TITLE:- 3LEAF RIGHT SIDE CRM DOOR 03

CLIENT - LESTECH

LOCATION - POSCO MANGAON

DWG NO:-NIHVA/22-23/CLT/0015 | REV- 0

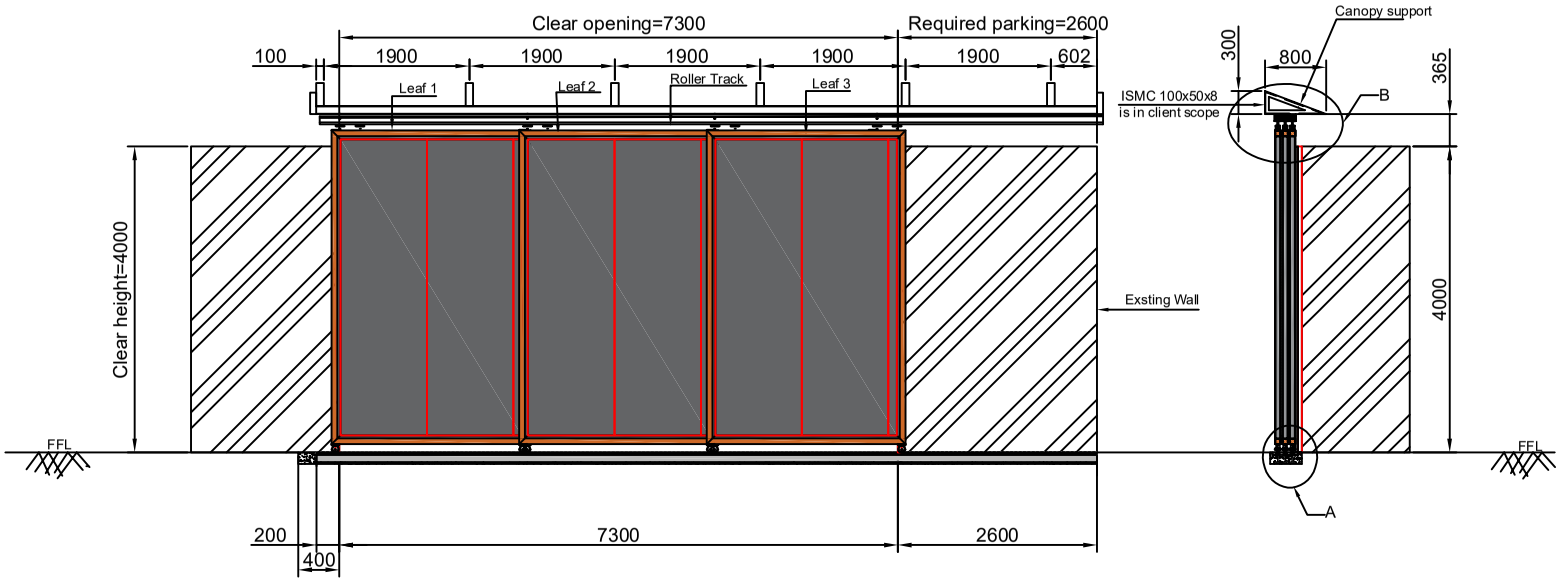
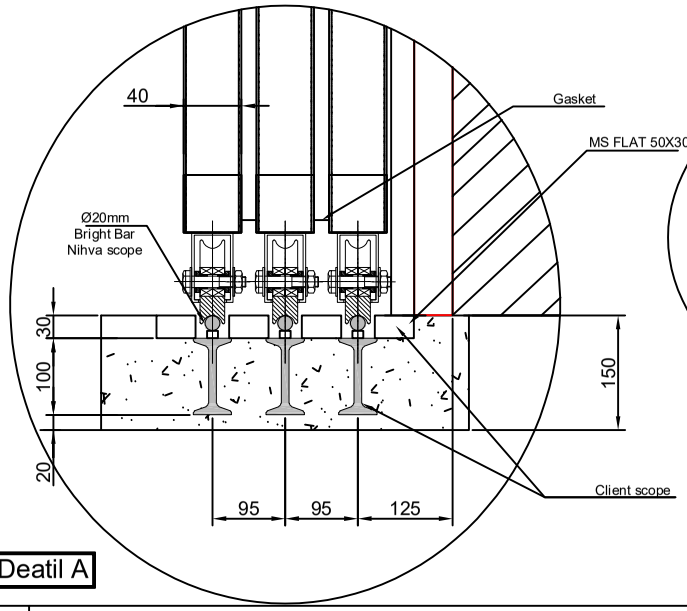
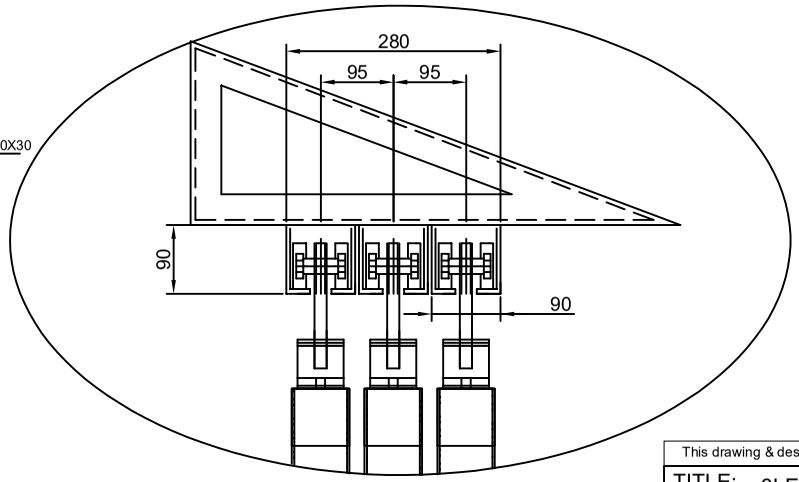
Client scope
* Drainage area or pipe need to be shift from right side *Roof need to be shift at top Approx 300mm *Gutter need to be close till pipe
